CUT PATTERN	
BACK FRAME NO.	
BASE FRAME NO.	
WOOD PATTERN

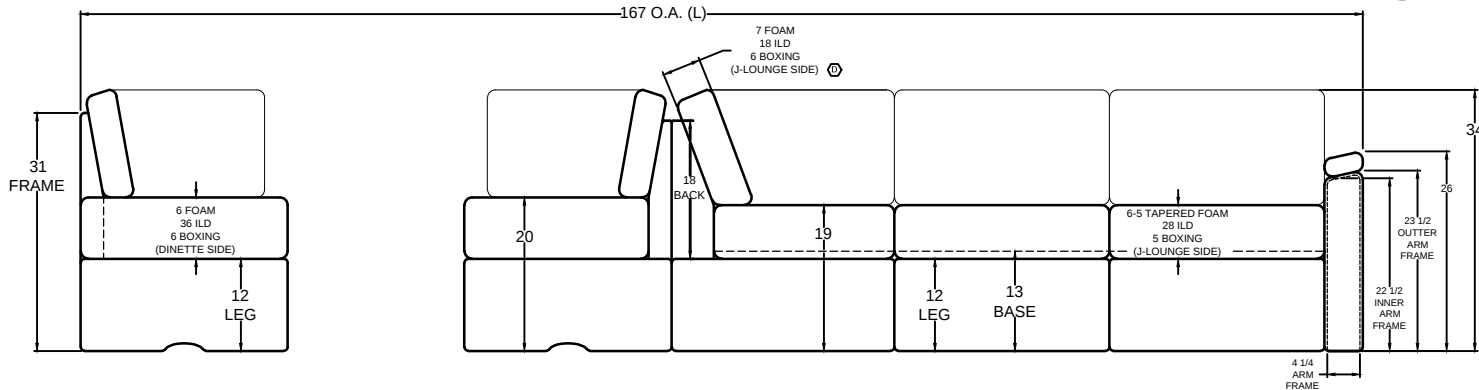
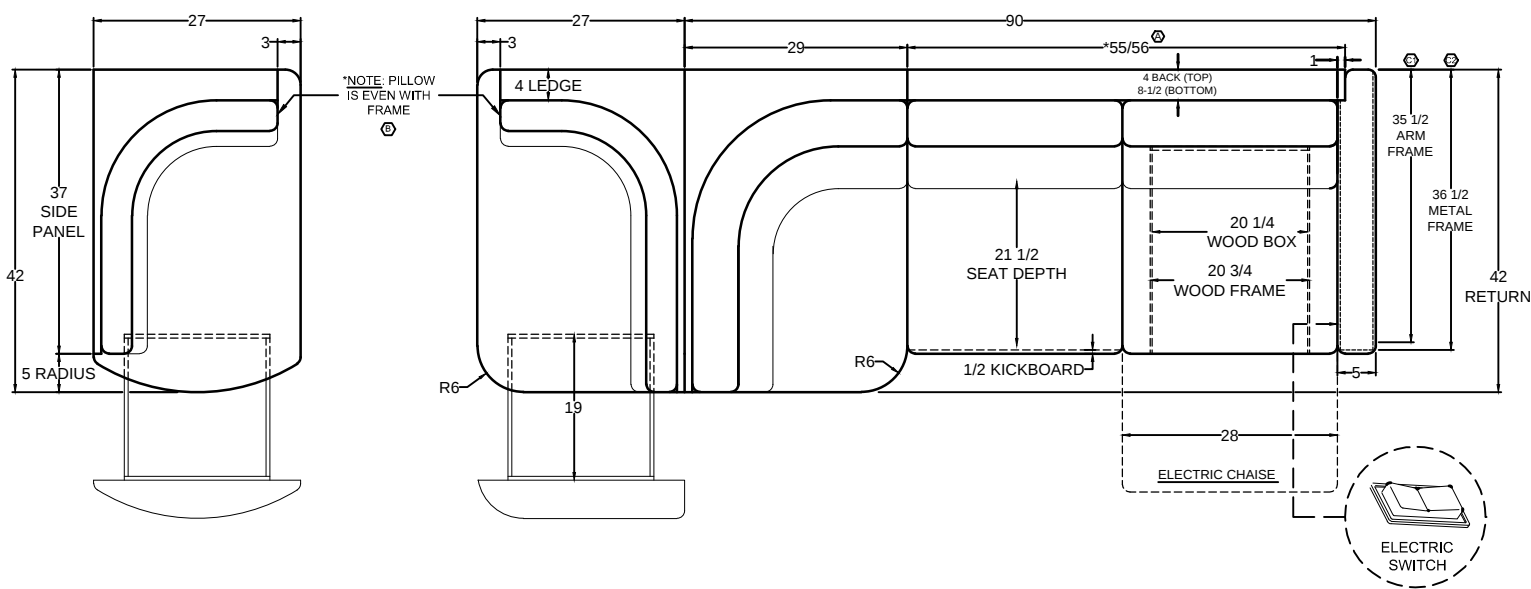
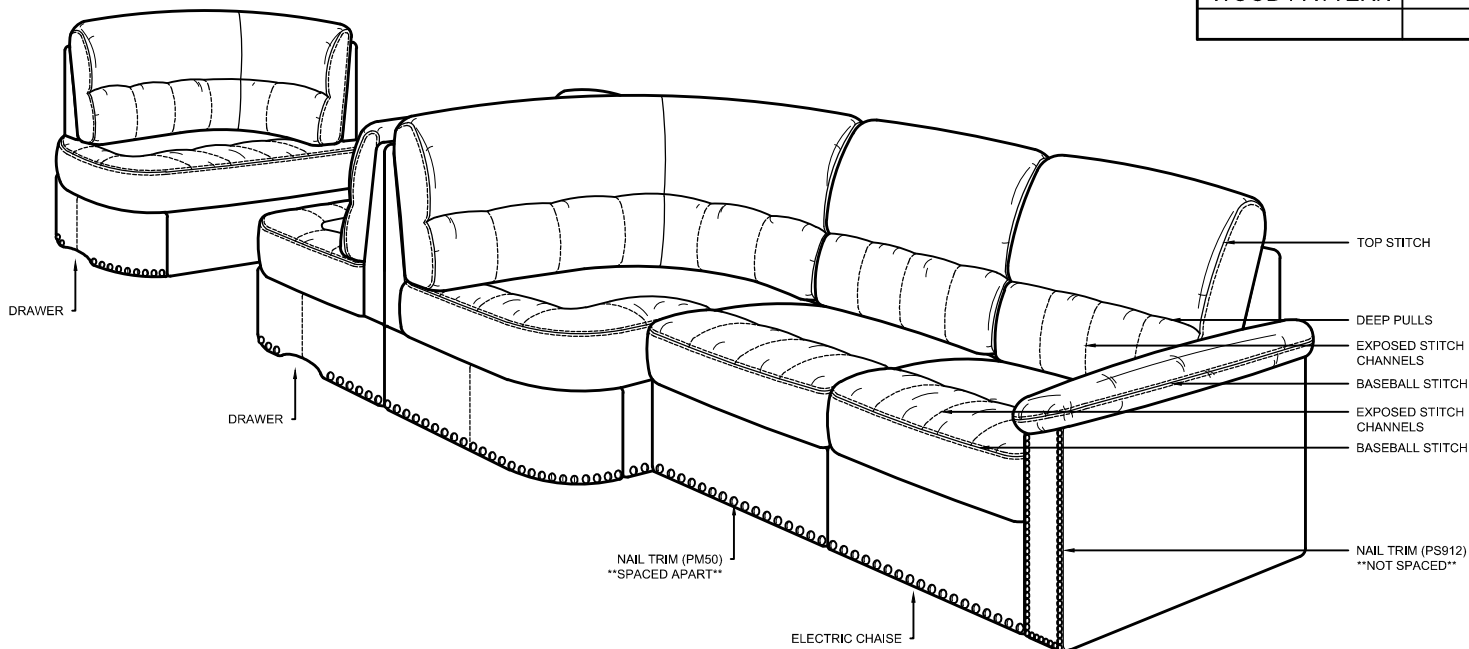
JA	D	CHANGE J-LOUNGE SIDE BACK PILLOW FOAM DETAILS TO 7 FOAM / 18ILD / 6 BOXING, WAS 4 FOAM / 18ILD / DOUBLE WRAP DACRON / 4 BOXING. (REF. ECO #009-2020)	02.13.2020
JA	C	[1] CHANGE ARM FRAME DEPTH TO 35-1/2"; WAS 32-1/2". [2] ADD 36-1/2" FRAME DEPTH DIMENSION TO DRAWING. (REF. ECO #004-2020)	01.15.2020
JA	B	PER RL, ADD NOTE TO DRAWING THAT WALL SIDE PILLOW IS EVEN WITH THE FRAME.	12.19.19
LB	A	WOOD UPDATE: CHANGED BACK FRAME WIDTH TO 55/56"; WAS 58/59"	11.05.19
